**WARRANTY
BULLETIN**

Wb01-10

DATE : OCTOBER 2001	SECTION :	18 - Body
EXPIRATION: OCTOBER 2002		
SUBJECT : INSTALLATION OF A DECAL ON THE RELEASE BAR OF THE SIDE WINDOW EMERGENCY EXITS

FIGURE 1

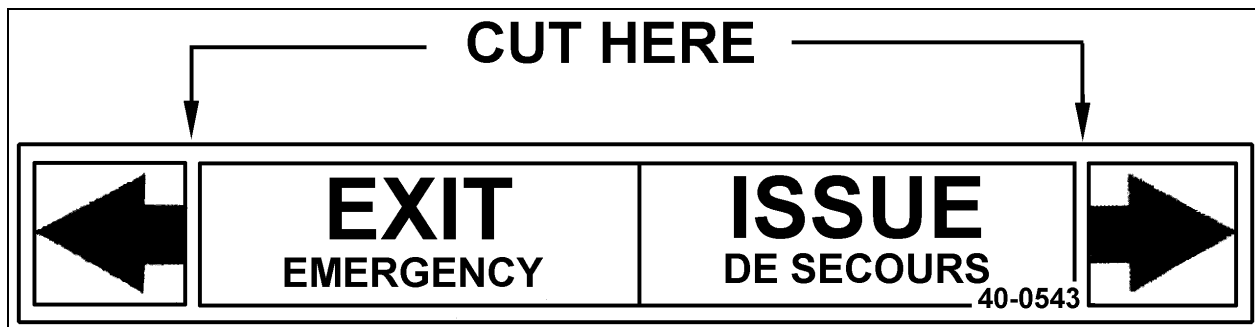
1. Verify inside vehicle that the decals were installed.
2. If the decals are missing, order the required quantity (Prevost #400543).
3. Cut the arrow at each extremity of the decal then affix the decals to the required locations (refer to figure 1 and 2).
